UNITED STATES PATENT AND TRADEMARK OFFICE

APPLICATION NO.	FILING DATE	FIRST NAMED INVENTOR	ATTORNEY DOCKET NO.	CONFIRMATION NO.
10/790,217	03/02/2004	Akira Yoneoka	P21-163407M/NY	9855

Office Action Summary

DETAILED ACTION

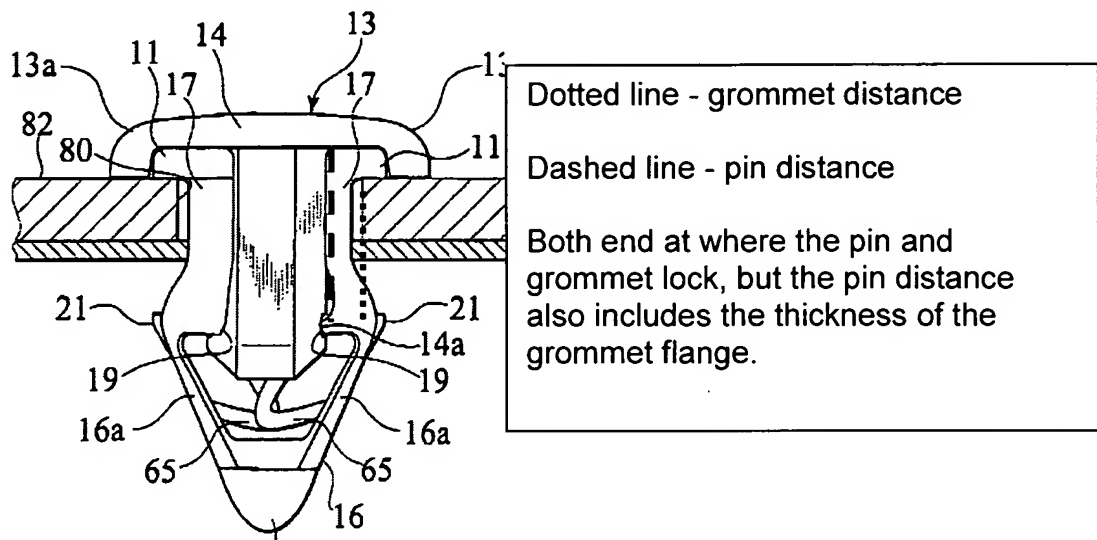
Re claim 12; The engagement portion 19 comprises a protruding portion extending from the leg inner surface.

Re claim 13: There are a plurality of slits (best seen Fig 22 -- between leg portions 16a and 16a, and also having hinges 55 in the slits) in the grommet dividing the leg into a plurality of leg pieces.

Re claim 14: Anything below the dashed line by examiner is considered where an expanded tip end side of the leg begins. Note that Fig 29 shows how this section expands when inserted. The engagement portion is formed on the inner surface of this tip end side.

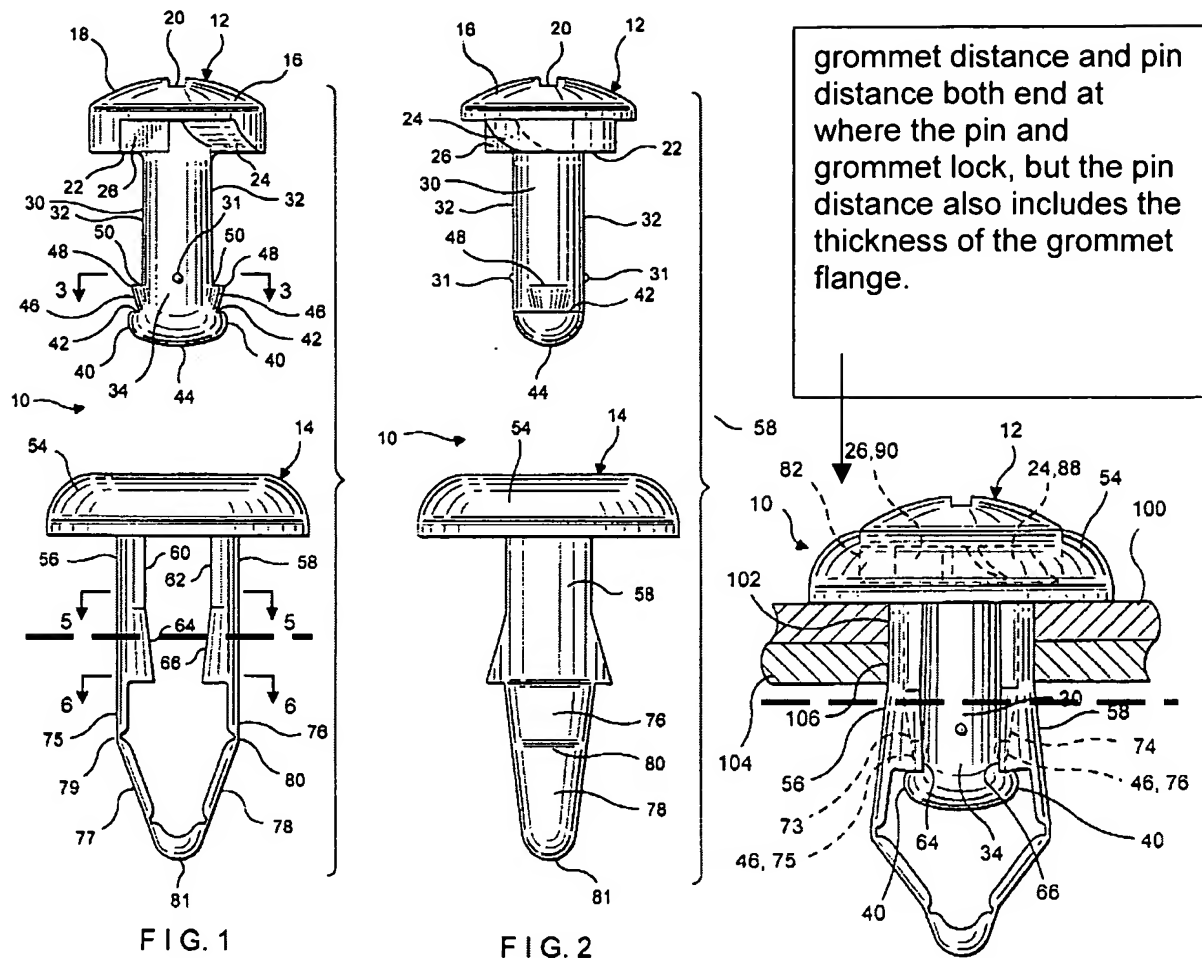
Re claim 12; The engagement portion comprises a protruding portion extending from the leg inner surface - see Fig 1 and 9.

Re claim 13: There are a plurality of slits (best seen Fig 1 -- between leg portions 77,78, in the grommet dividing the leg into a plurality of leg pieces.

Re claim 14: Anything below the dashed line by examiner is considered where an expanded tip end side of the leg begins. Note that Fig 9 shows how this section expands when inserted. The engagement portion is formed on the inner surface of this tip end side.

Re claim 21: The distance from the grommet flange to the grommet engagement portion is smaller than the distance from the pinhead to the pin lock surface (best seen in Fig 9)
